Access Compliance Report Public Rights-of-Way (Curb Ramps)

Intersection ID: N/AMain Street: HAMILTON_BRIDGE_RDCross Street: OBAN_PASSAGE_DRLocation:NEADA ID: 604305ECAAD9Ramp Type: PerpInitial Pass/Fail: FailOverall Compliance: NoSeverity Score: 22.5

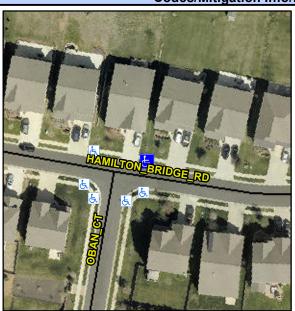
Possible Solutions:						
Remove & Replace Entire Ramp.						
	i					
Surveyor Notes:	ı					
N/A	I					
	ı					
PROW/ADA:						
Not Found, R304.5.1, R304.2.2	ı					
	ı					
	ı

Field Measurements/Component Compliance						
Compl	iance Description	Data	Comp	liance Description	Data	
N/A	Ramp Length (in)	47.0	No	Ramp Slope (%)	10.6	
No	Ramp Width (in)	47.0	Yes	Ramp XSlope (%)	3.0	
N/A	Flare Type LT	N/A	N/A	Flare Type RT	N/A	
N/A	Flare Slope LT (%)	N/A	N/A	Flare Slope RT (%)	N/A	
N/A	Flare Traversable LT?	N/A	N/A	Flare Traversable RT?	N/A	
N/A	Landing Length (in)	N/A	N/A	DWS Provided?	N/A	
N/A	Landing Width (in)	N/A	N/A	DWS Contrast?	N/A	
N/A	Landing Slope (%)	N/A	N/A	DWS Length (in)	N/A	
N/A	Landing X Slope (%)	N/A	N/A	DWS Full Width?	N/A	
N/A	Landing Curb? (Y/N)	N/A	N/A	DWS Offset (in)	N/A	
N/A	Shared Landing?	N/A				
N/A	Gutter Ponding?	N/A	N/A	Gutter Slope (%)	N/A	
N/A	Gutter Lip Ht (in)	1.0	N/A	Gutter X Slope (%)	N/A	
N/A	Painted X Walk1?	No	N/A	Painted X Walk2?	N/A	
	X Walk 1 Direction	To SW		X Walk 2 Direction	N/A	
N/A	X Walk 1 Width (in)	N/A	N/A	X Walk 2 Width (in)	N/A	
	X Walk 1 Slope (%)	1.9		X Walk 2 Slope (%)	N/A
